Product Change Notification

Date Issued :	October 03, 2023	PCN Number :	513749
Reason for Change :	Change to Product		
Description of Change :	Through a standardization process, all finished product lengths are standardized to one dimensioning and one Tolerance type.		
Assessment of Change :	Dimension analysis		
Planned Implementation Date :	June 28, 2024		
Sample Availability Date:	November 24, 2023		
Internal Molex Qualification Date :	December 06, 2023		
Last date to request Samples by Customer :	December 22, 2023		
Traceability Code Markings / Date :	No special marking on the product or packaging

Before Picture

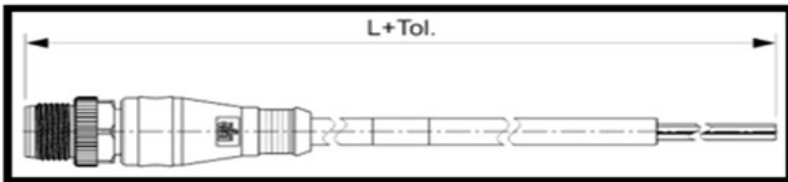
- Through a standardization process, all finished product lengths are standardized to one Dimensioning and one Tolerance type.

CABLE LENGTH TOLERANCES	
LENGTH	TOLERANCE
0 m - 1 m	+40 mm
>1 m - 5 m	+60 mm
>5 m - 10 m	+80 mm
>10 m - 20 m	+140 mm
>20 m - 30 m	+160 mm
>30 m	+1% length
